Status of 802.1AS-Rev/D5.1 and Questions on Several Items Needing Resolution

IEEE 802.1 TSN TG
2017.11.06

Status of comments against D5.0

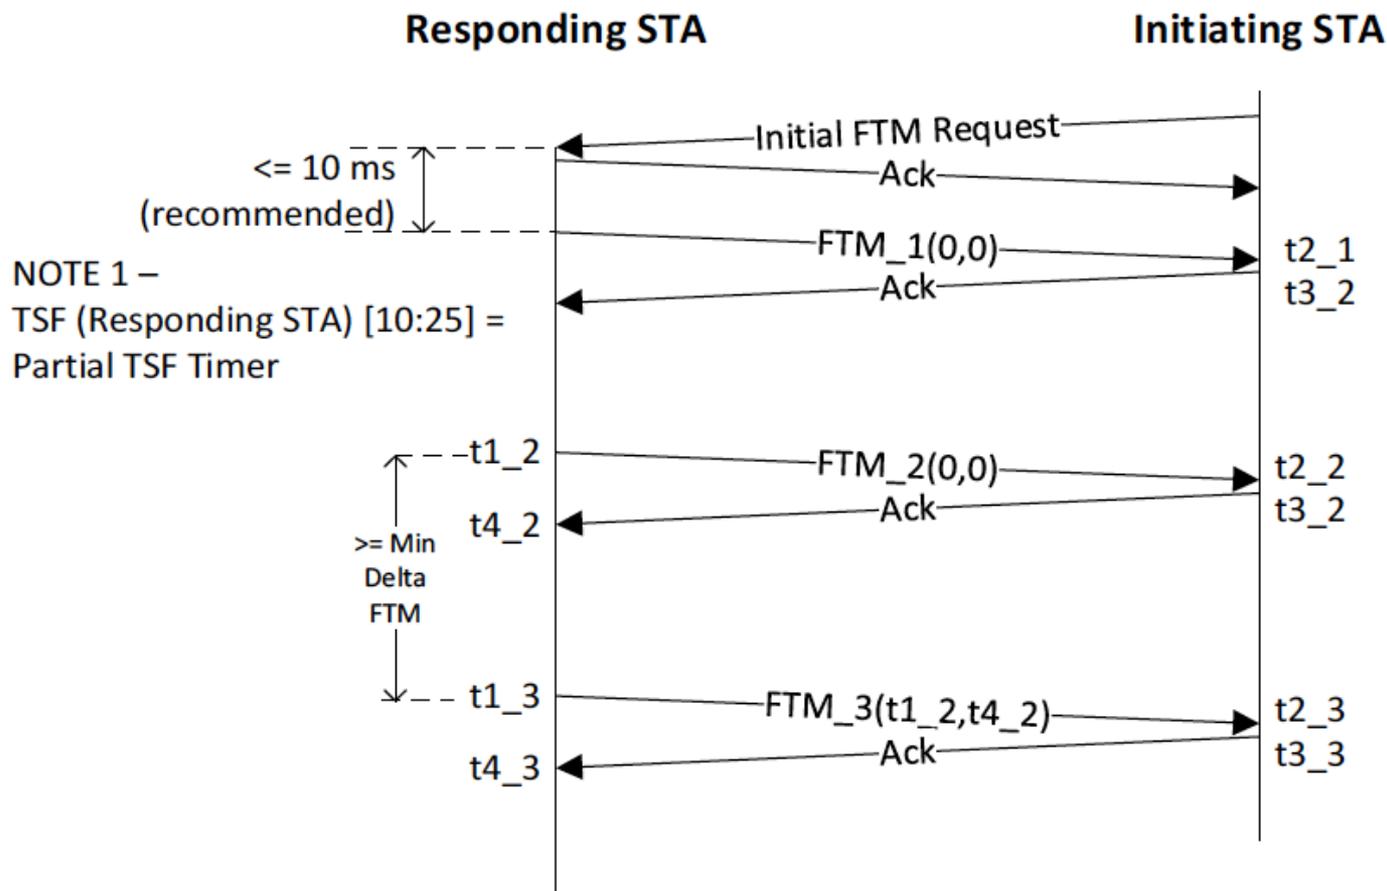
- The following presentation ([1] in the references at the end of the presentation)_ outlined 5 proposed solutions for handling FTM in 802.1AS-Rev (they were designated A, B, C, D, and E)
 - Ganesh Venkatesan, “IEEE 802.1AS REV D5.0 Review Comments” (available via <http://www.ieee802.org/1/files/public/docs2017/as-venkatesan-Review-Comments-on-the-use-of-FTM-07-17.pdf>)
- Unfortunately, the resolutions for comments against D5.0 pertaining to FTM do not explicitly say which approach we will use
 - However, it is the recollection of the editor that we will use approach D
 - The editor would like to confirm this
 - In the following slides, we work from this assumption in discussing values for various FTM parameters

Figure 11-37—Example negotiation and measurement exchange sequence for a single burst instance, ASAP=1, and FTMs per Burst = 3

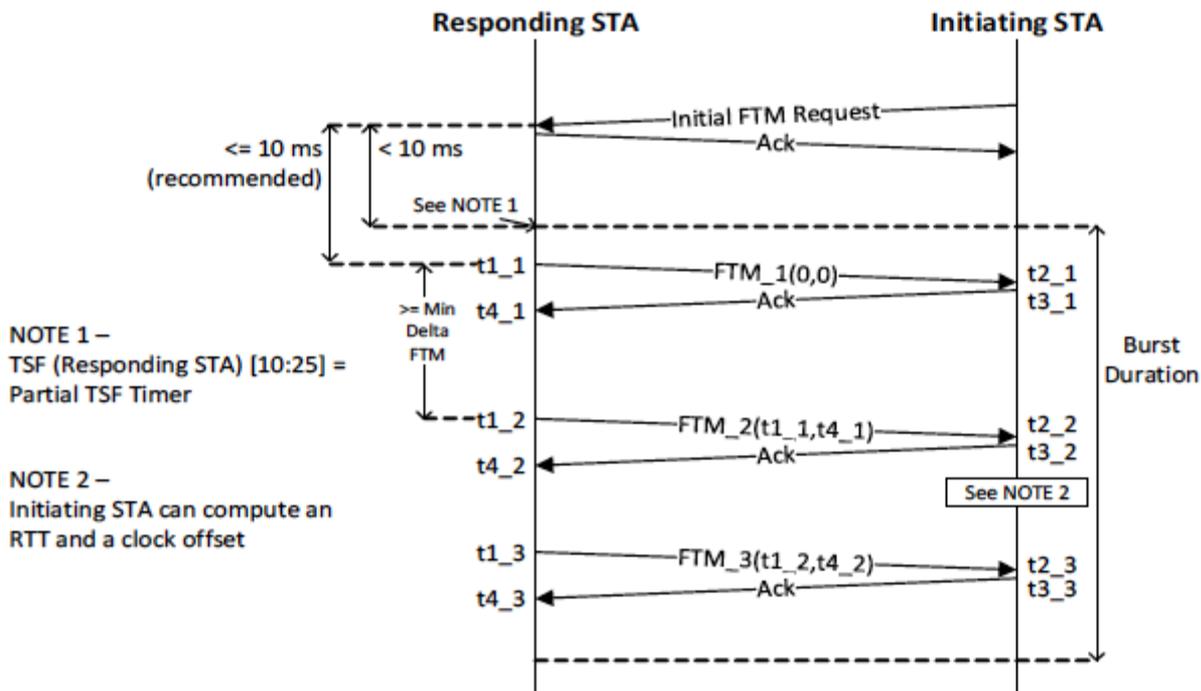
- The measurement exchange figures in 11.24.6.4 of 802.11-2016 (e.g., Figure 11-37) refer to the “Initial FTM Request”; related to this, comment #11 refers to an “iFTMR” that the Slave sends to the master

- However, 802.11-2016 describes only the MLME-FINETIMINGMSMTRQ.request; there is no “MLME-INITIALFINETIMINGMSMTRQ.request”
 - It appears the use of “Initial FTM Request” simply means that this is the first (or initial) FTM Request; it is not meant to be a different message or primitive from the FTM Request

- The editor would like to confirm (or at least clarify) this
 - Related to this, comment #11 refers to the master responding to the iFTMR with an iFTM after sending the ACK to the iFTMR

- However, the figures in 11.24.6.4 simply show normal FTM messages that follow the ACK (with each FTM having a corresponding ACK)
 - It appears that the iFTM is simply the first of these FTM messages

- The editor would like to confirm (or at least clarify) this

- ❑ The figures on the previous 2 slides are almost the same; the biggest difference is that the former does not show the burst duration
- ❑ It is assumed below that the exchange shown in these two figures will be used for FTM in 802.1AS-Rev
- ❑ In addition, it is assumed that each session will contain a single burst as illustrated in these two figures
- ❑ With these assumptions, we can begin to suggest values for various FTM parameters, on the following slides

- ❑ From Figure 11-37 of 802.11 (shown on slide 12), which shows the message exchanges in the burst
 - Min Delta FTM < Burst Duration
 - It appears that we can assume that $3 * (\text{Min Delta FTM}) < \text{Burst Duration}$
 - $10 \text{ ms} + \text{Burst Duration} < \text{mean Sync Interval}$
- ❑ Mean sync interval, in seconds, must be a power of 2 (requirement of 1588 and 802.1AS)
- ❑ Min Delta FTM is a multiple of $100 \mu\text{s}$ (from 9.4.2.168 of 802.11-2016)
- ❑ Burst Duration, in ms, is a power of 2, ranging from 0.25 ms ($250 \mu\text{s}$) to 128 ms (see Table 9-257 of 802.11-2016)
 - i.e., 0.25, 0.5, 1, 2, 4, 8, 16, 32, 64, 128 ms
